AROMA JOES
SITE PLAN APPLICATION #08-21
STAFF REPORT
August 25, 2021

SITE: 56 Derry Street; Map 173 Lot 029-000

PURPOSE OF PLANS: Propose an Aroma Joe's drive-thru coffee shop at 56 Derry Street with associated parking and drives.

Re: Town of Hudson Planning Board Review
Aroma Joe's Site Plan, 56 Derry Street
Tax Map 173 Lot 29; Acct. #1350-970
Reference No. 20030249.2040

SIGHT DISTANCE PLAN
SCALE: 1" = 30'

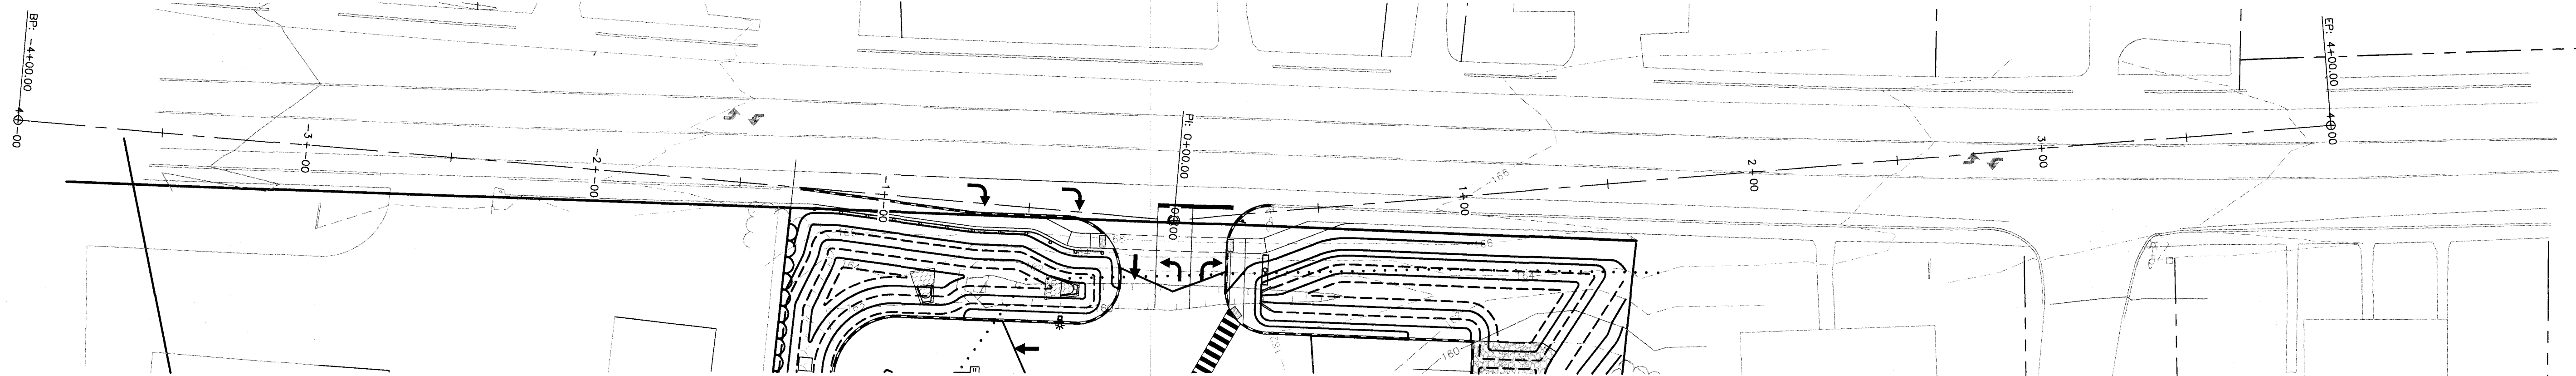
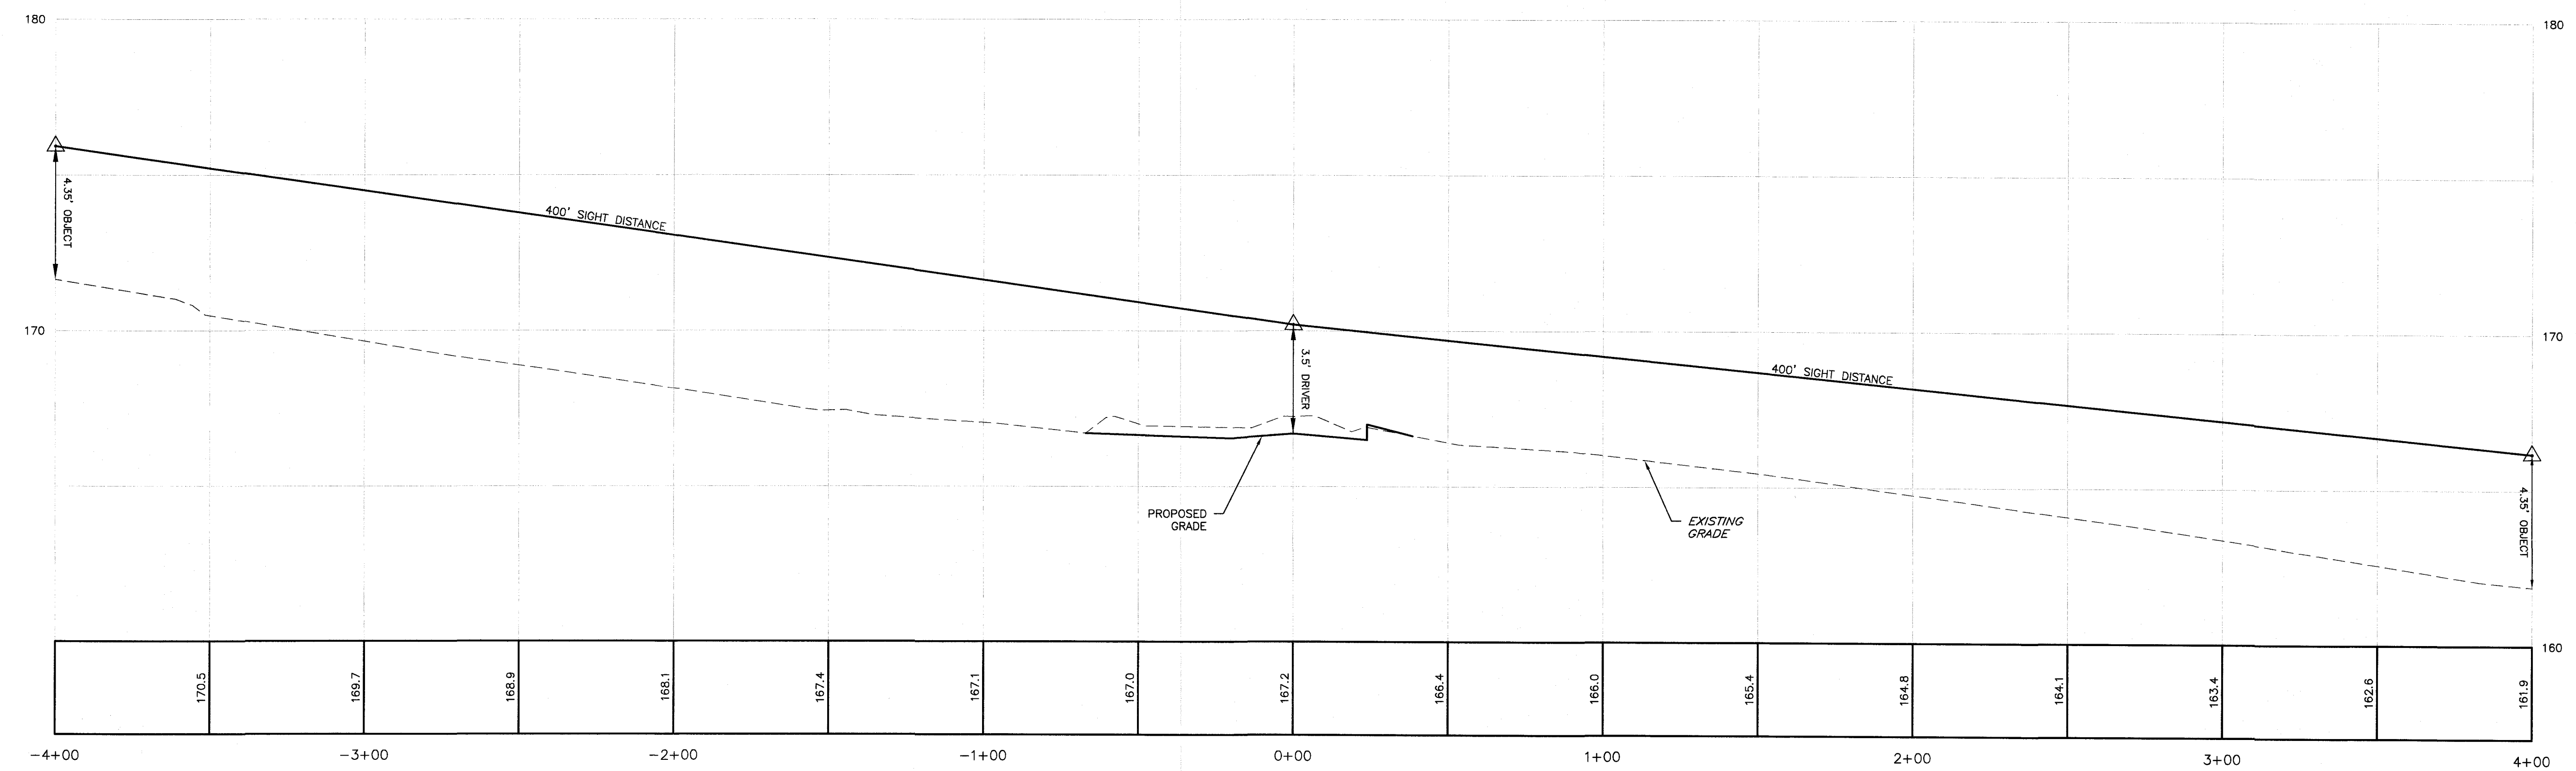
- b. *Former Fuss & O'Neill Comment: HR 193.10.E. The applicant has not provided any sight distances for the proposed driveway location on the plan set.*
Current Fuss & O'Neill Comment: The applicant has added sight distance information to the plan set. No further Fuss & O'Neill comment.

VERTICAL GRANITE CURB DETAIL
NOT TO SCALE
(MARCH 2008)

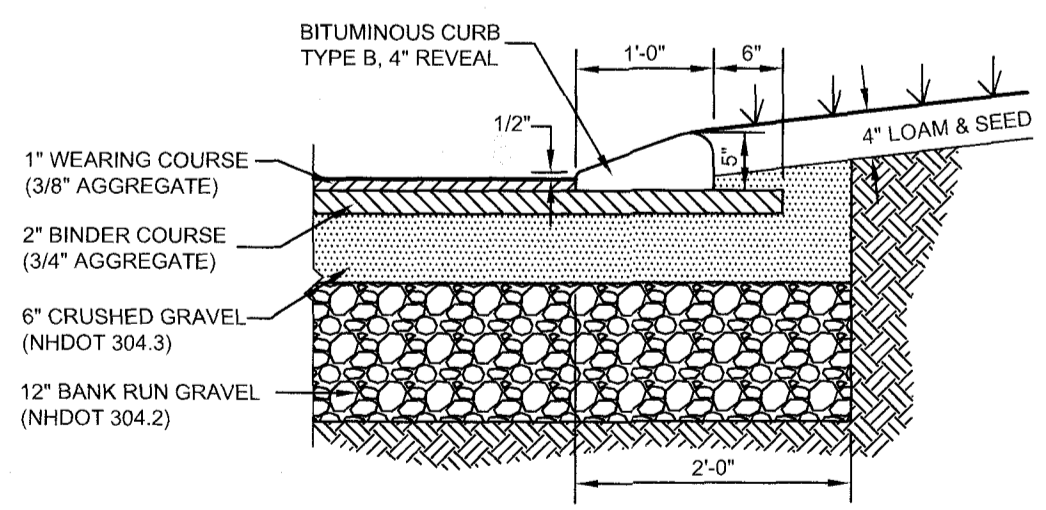
- d. *Former Fuss & O'Neill Comment: The applicant has called for vertical granite curb on the plan set and provided a detail for bituminous curb only. The applicant should coordinate the plans and details.*
Current Fuss & O'Neill Comment: The applicant has added the vertical granite curb detail to the plan set. No further Fuss & O'Neill comment.

SIDEWALK RAMP
NOT TO SCALE
(JUNE 2012)

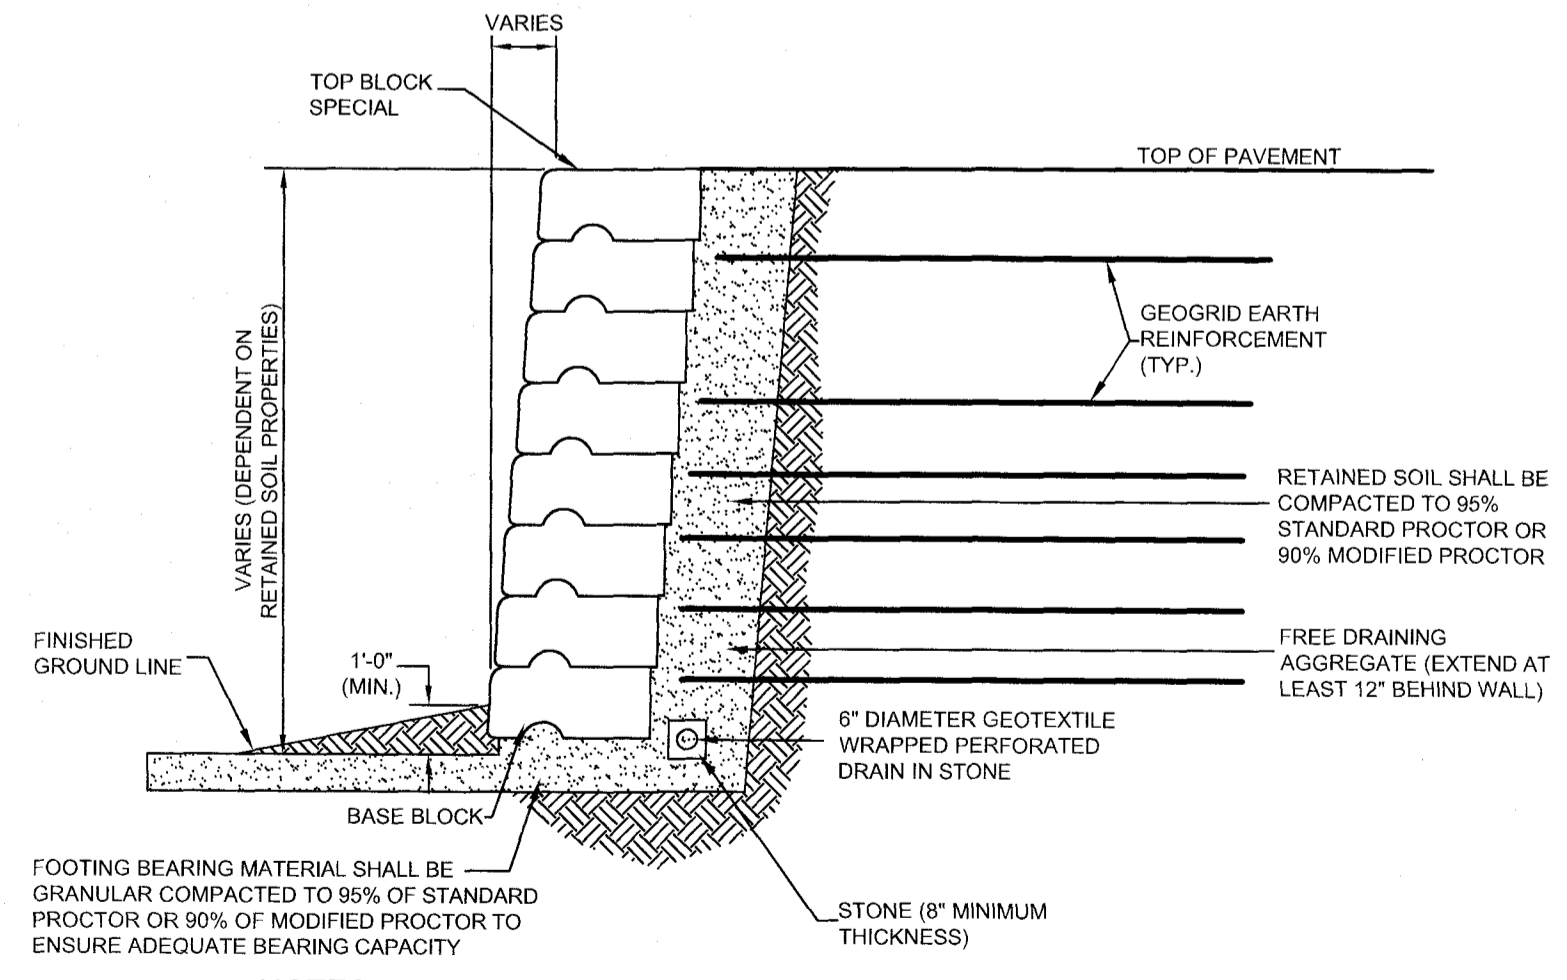
Current Fuss & O'Neill Comment: The applicant has provided spot grades for the parking lot ramp locations. We continue to recommend spot grades be provided for the sidewalk ramps as well.

UTILITY SEPARATION (MAIN) DETAIL
(A-01)
NOT TO SCALE
(MARCH 2008)

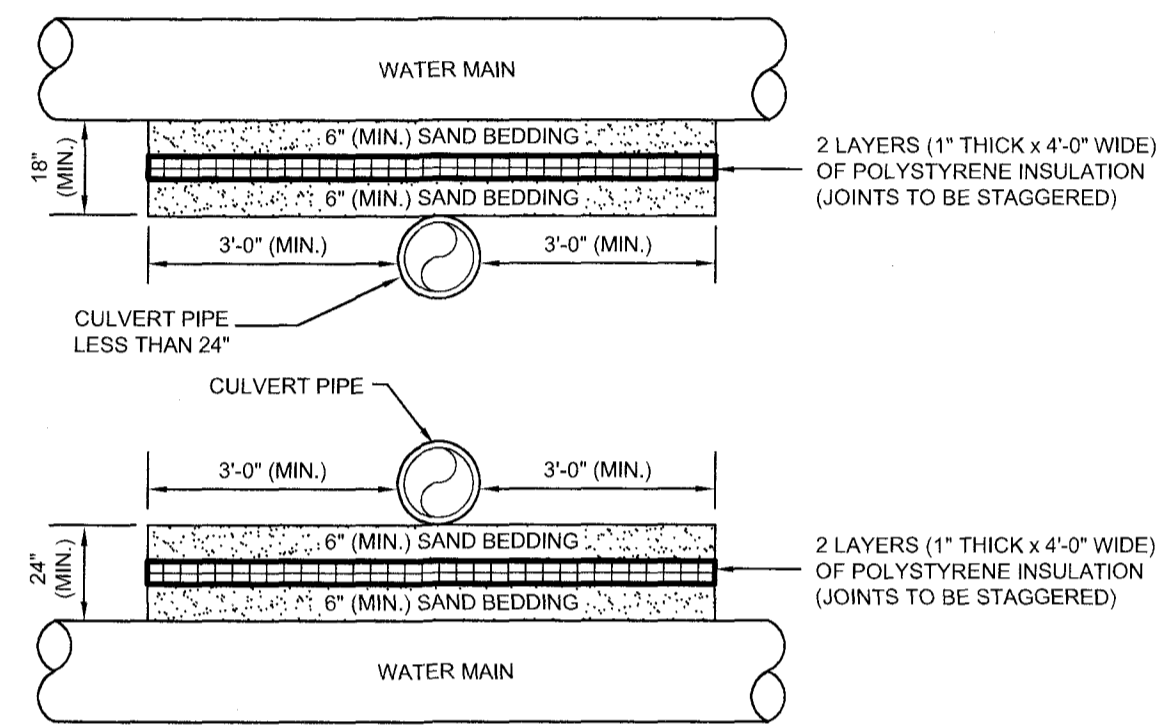
- b. *Former Fuss & O'Neill Comment: The applicant should provide a water/sewer crossing detail for the sewer service crossing the water main in Derry Street, and crossing details for the service piping at the drain line in the driveway.*

Current Fuss & O'Neill Comment: The applicant has provided the recommended detail on the plan set. No further Fuss & O'Neill comment.

DATE: JUNE 22, 2021
PROJECT NO: 21-0311-1
SCALE: 1"=20'
SHEET E1 OF E1

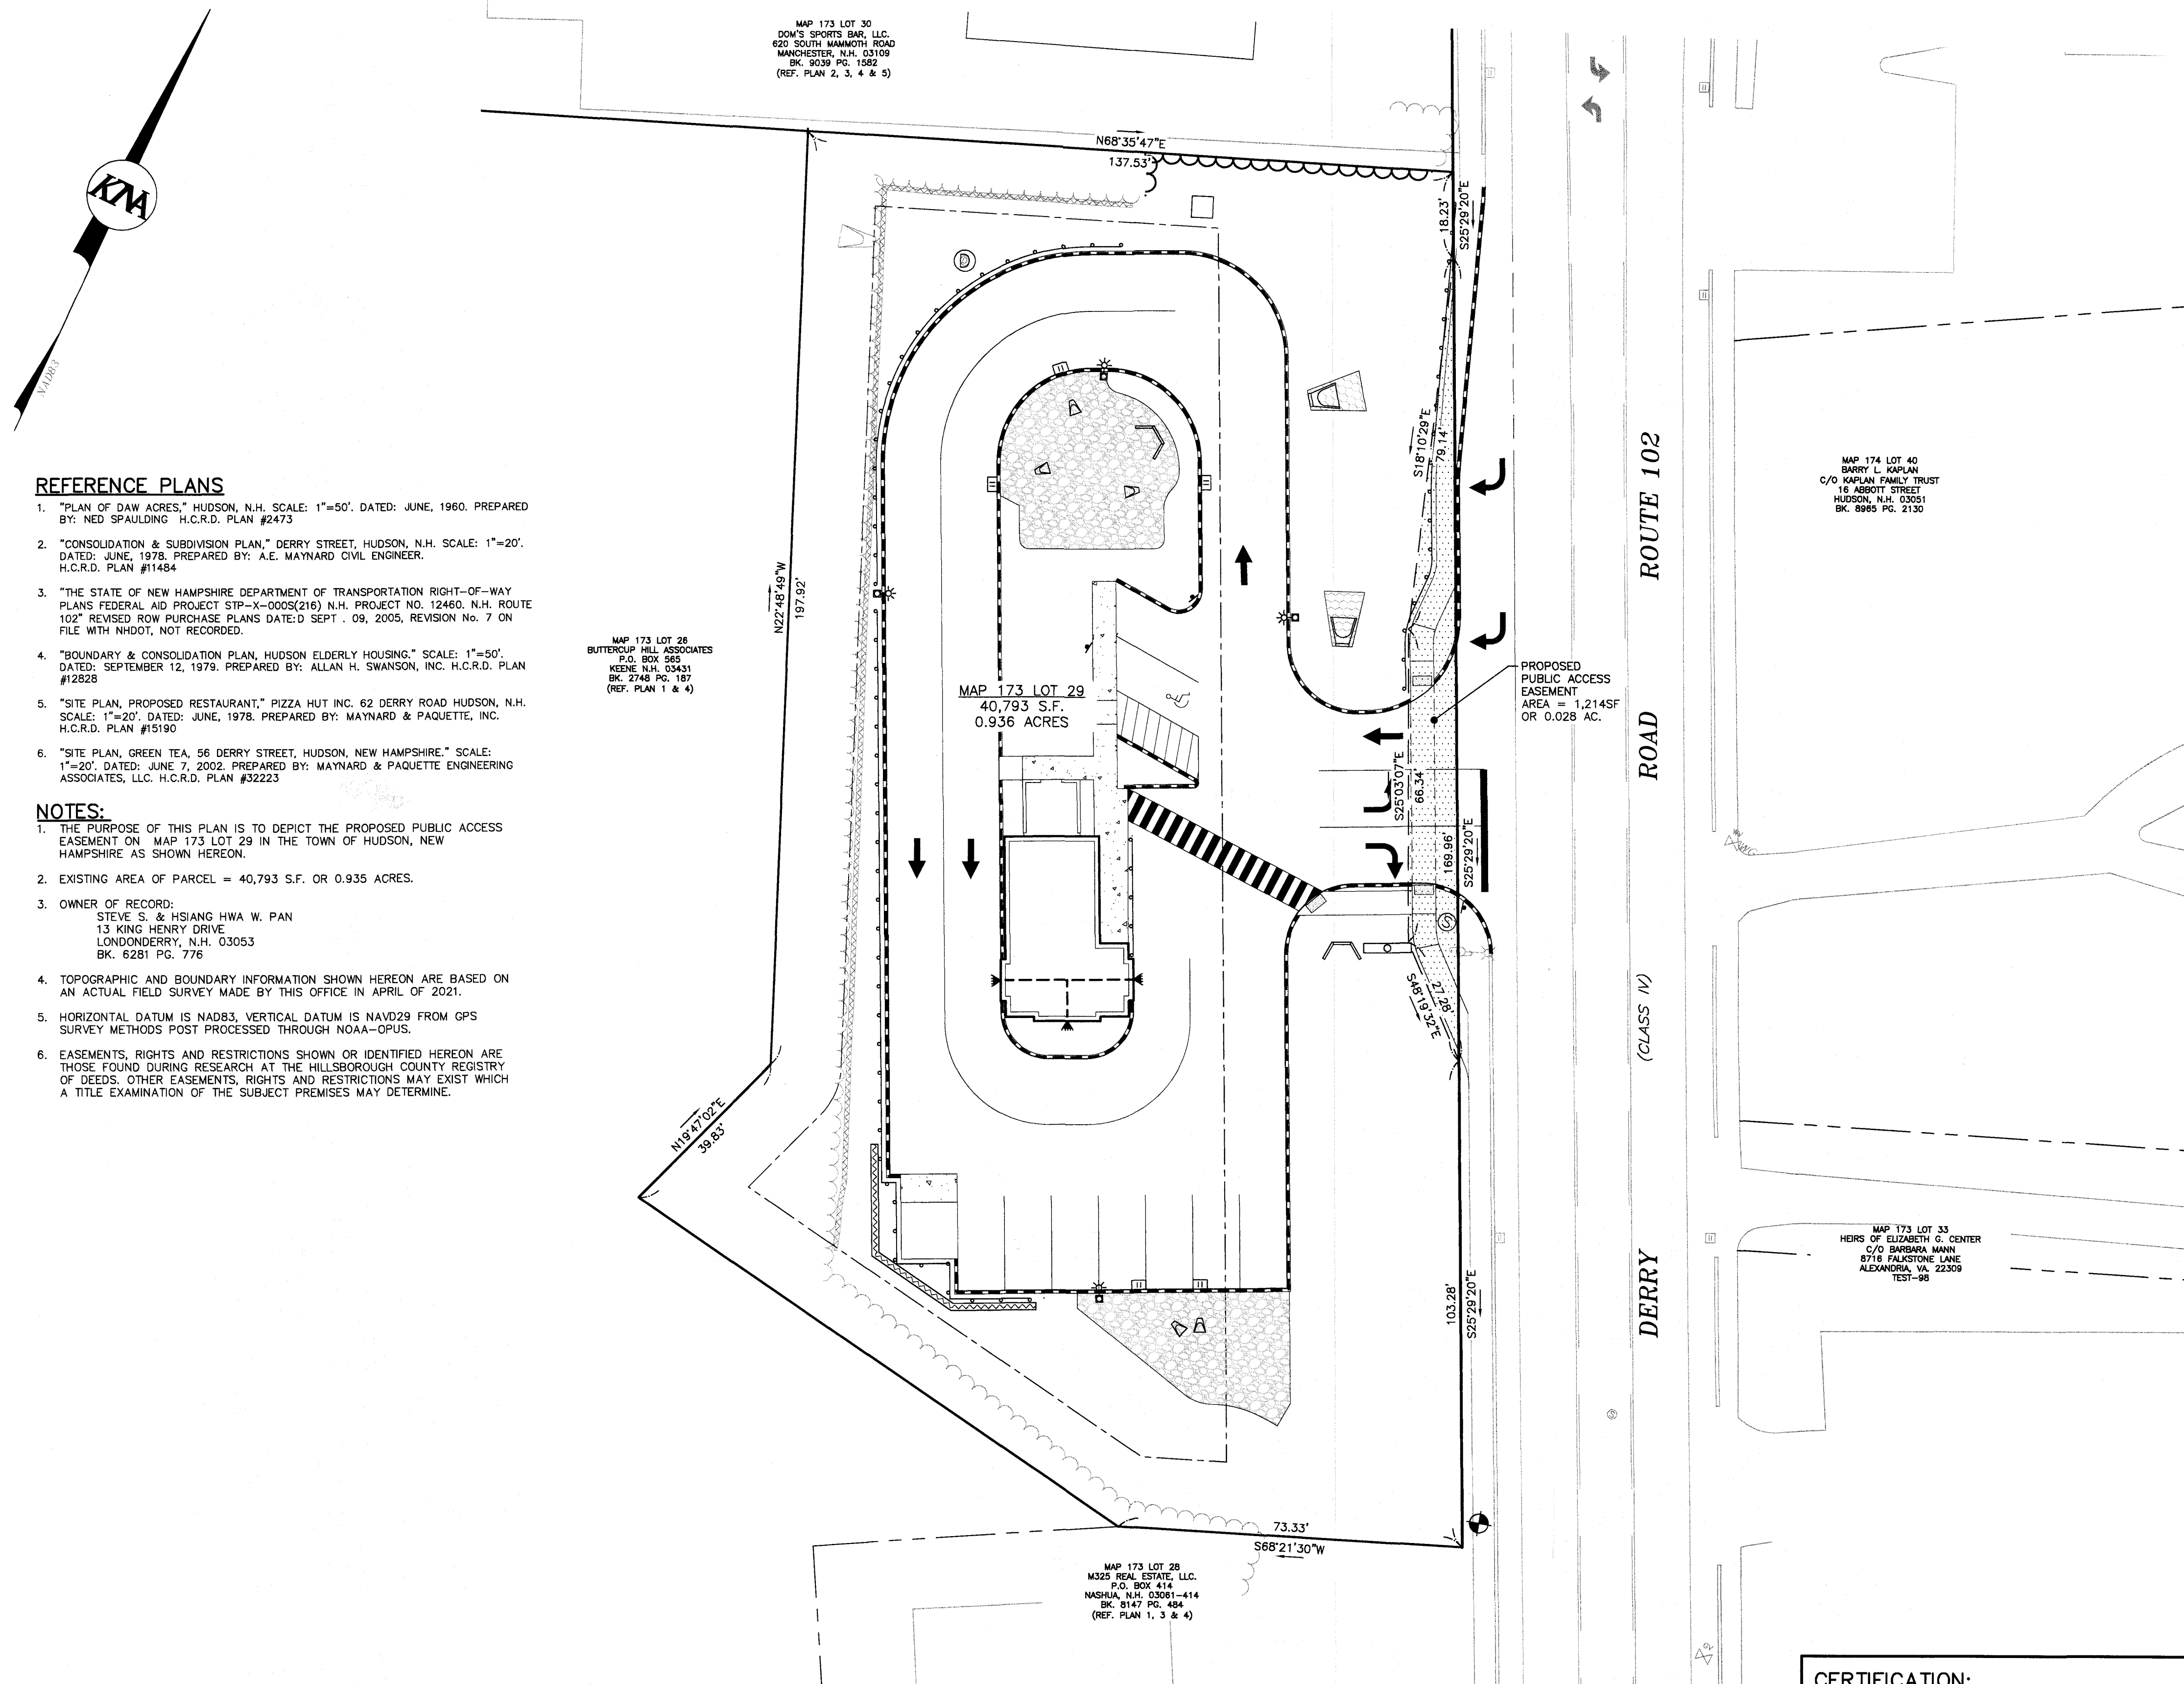
2. The proposed freestanding sign shows on Sheet 1 and the detail of the sign is on Sheet 10.
3. A crosswalk has been added per request at previous meeting.
4. The proposed sidewalk easement shows on Sheet E1.
5. The loading space and dumpster location are clearly identified on the plan

Current Fuss & O'Neill Comment: The applicant has stated that no easements or deeds are required. We continue to recommend a sidewalk easement be provided to the Town for the relocated sidewalk.
